Woodridge ES
Change Order - Breakdown

RE: Woodridge Elementary School Major Building System Replacement
IOC #004 – Addendum #001, Dated 05/23/23

Project Name: Woodridge Elementary School Major Building System Replacement
Location: 4120 Cedar Ridge Trail. Stone Mountain, GA 30083
Architect: Cooper Carry
Description of Change: ADDENDUM #001, DATED 05/23/23

1 A2.10 OVERALL PLAN
SCALE: 1/16" = 1'-0"

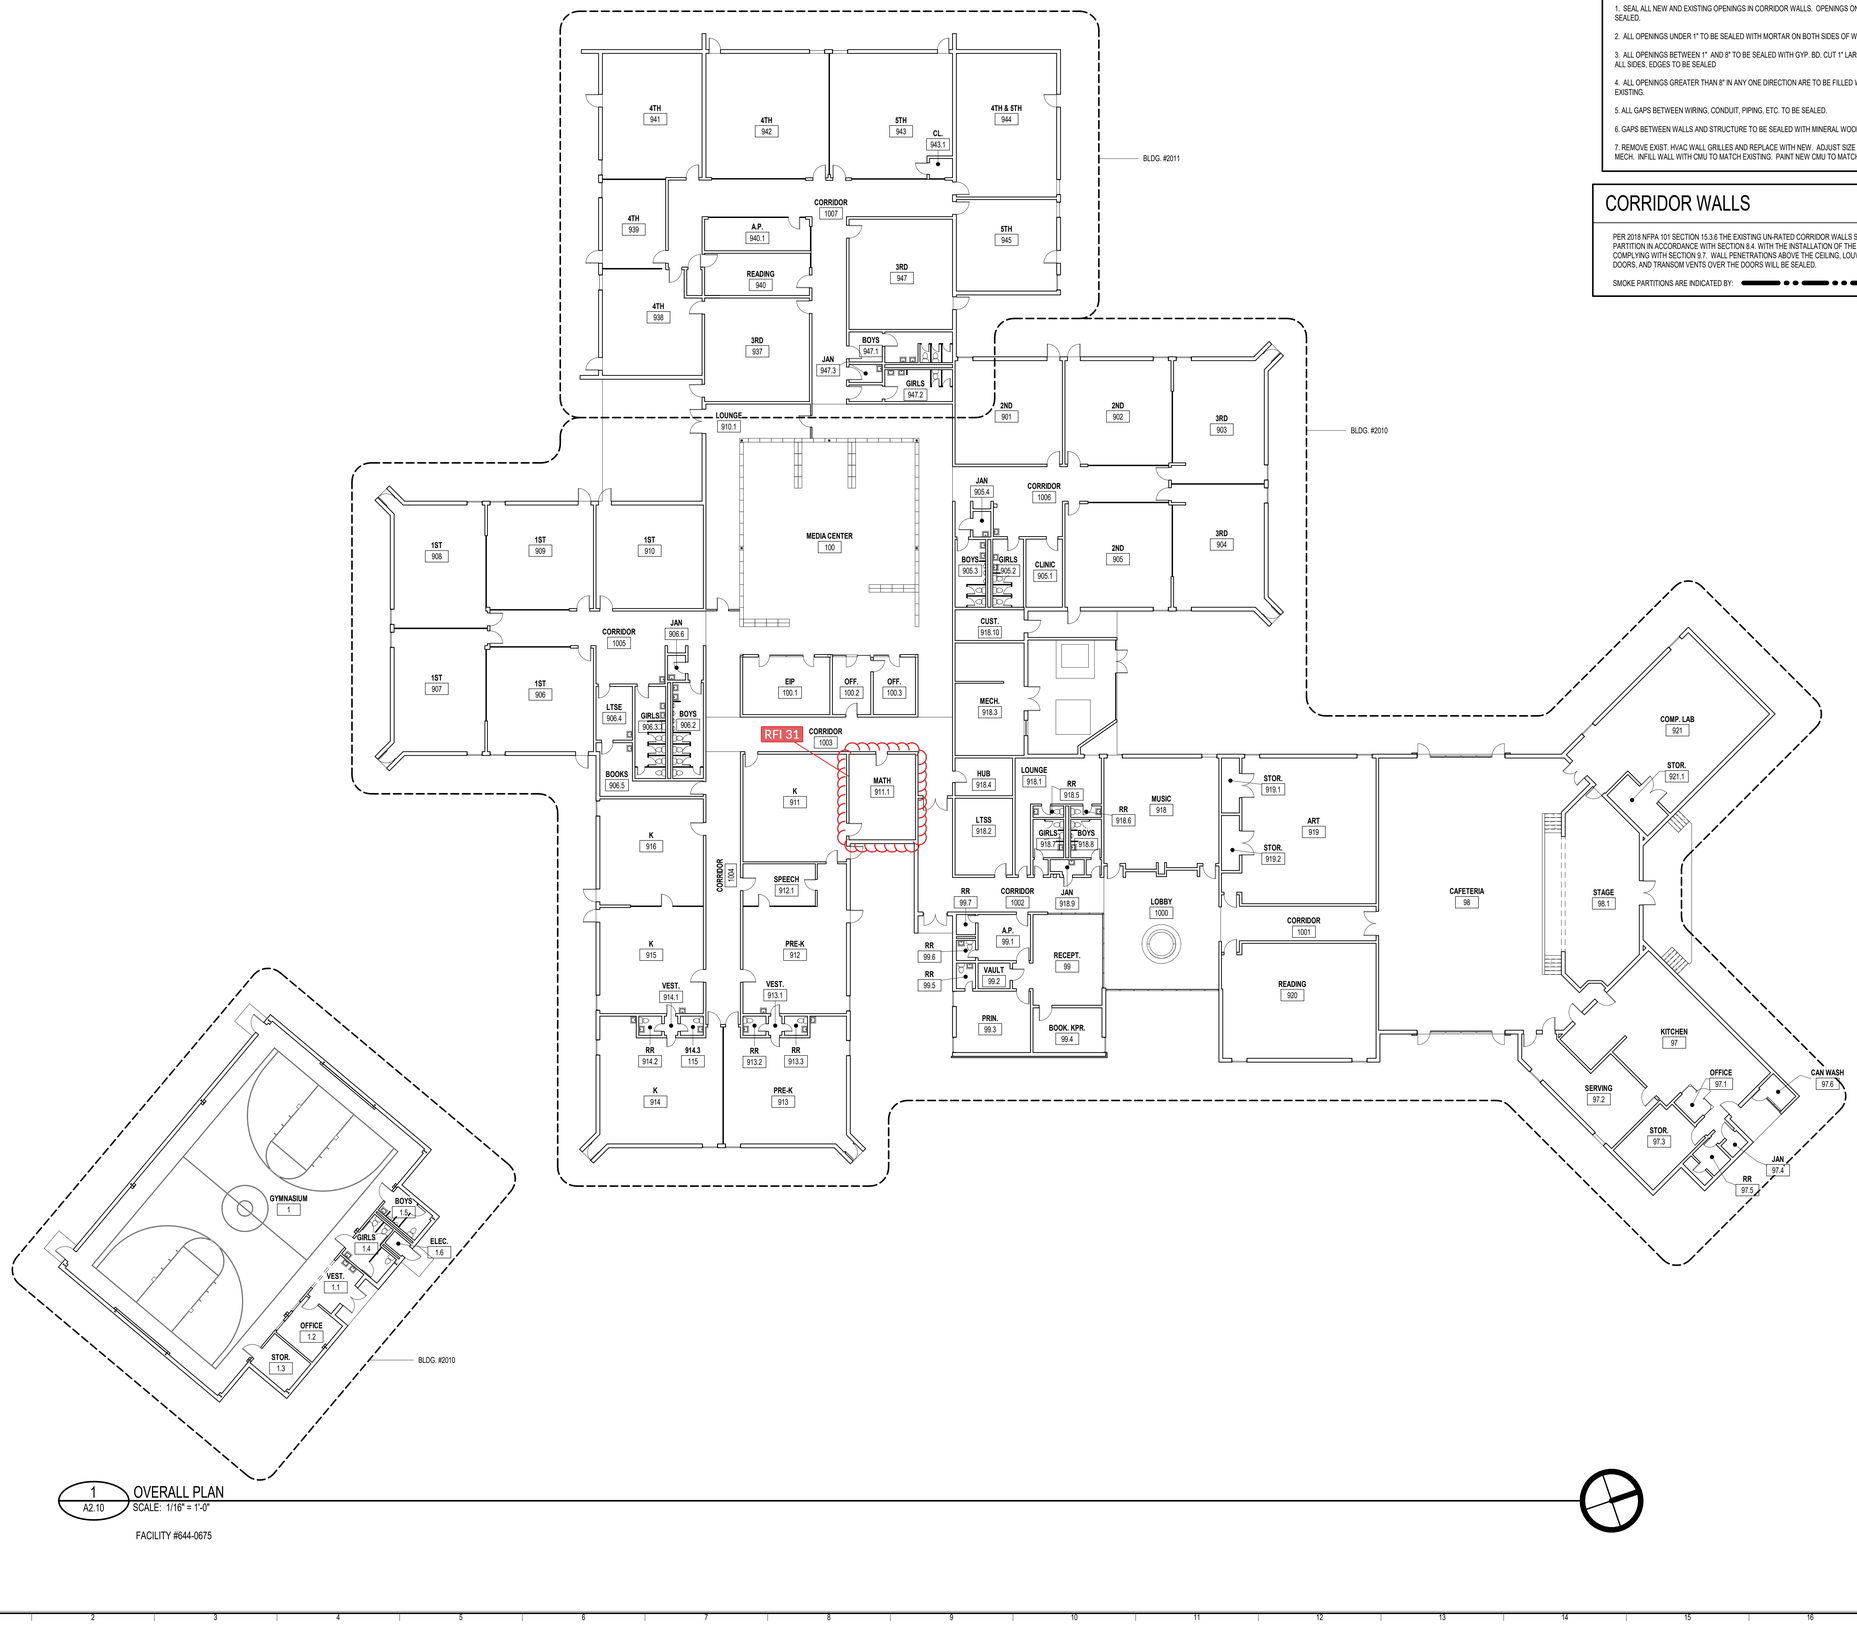
Question:
Please provide an updated drawing displaying which bathrooms are and are not ADA-compliant.
